City of White Rock Mayor and Council Members City of White Rock Planning Dept. March 19, 2021

WestStone Group's Development Application File No. MJP 19-011 Subject Properties: 14937 Thrift Avenue, 1441, 1443-45, and 1465 Vidal Street

EVERALL STREET

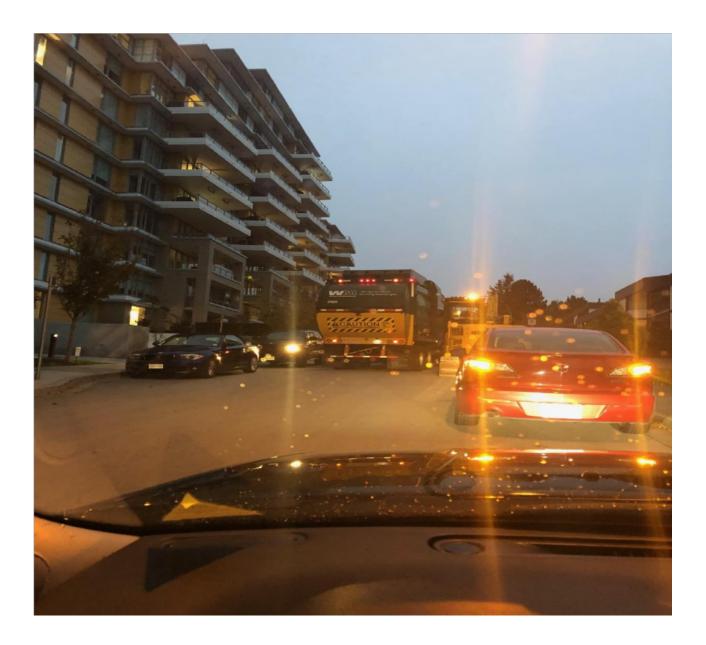
Everall Street, just 1 block west, at about its mid-length, looking north to North Bluff Road. It is 36 ft. wide, and has 4 fairly wide travel lanes. The street could be delineated into 5 lanes, should there be any need for it.

It services 3-storey townhouses and apartment buildings on its east side, a seniors' home (with light traffic), and the Royce (with no parkade access off this street) on its west side.

MARTIN STREET

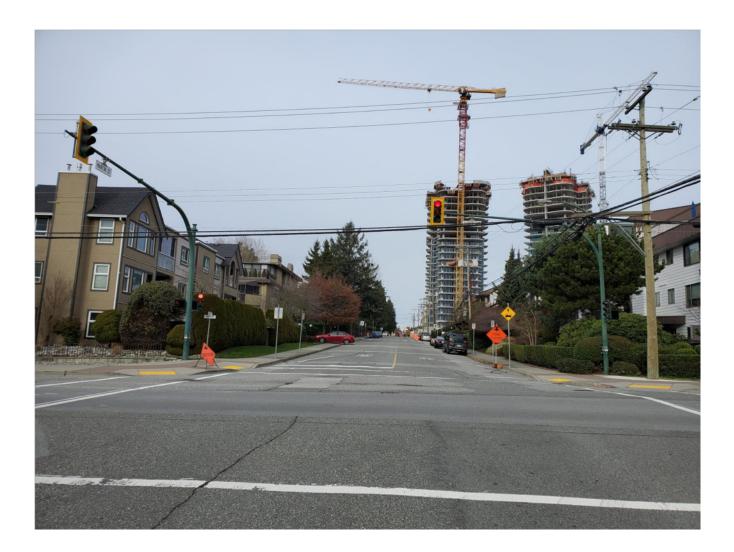
Martin Street at Thrift, looking north, just 2 blocks east of Vidal. It has 5 sizable travel lanes. It resembles Vidal Street with the Foster Martin high-rise towers on one side and the shorter 3-storey buildings on the other. But it has 2 more travel lanes to service them.
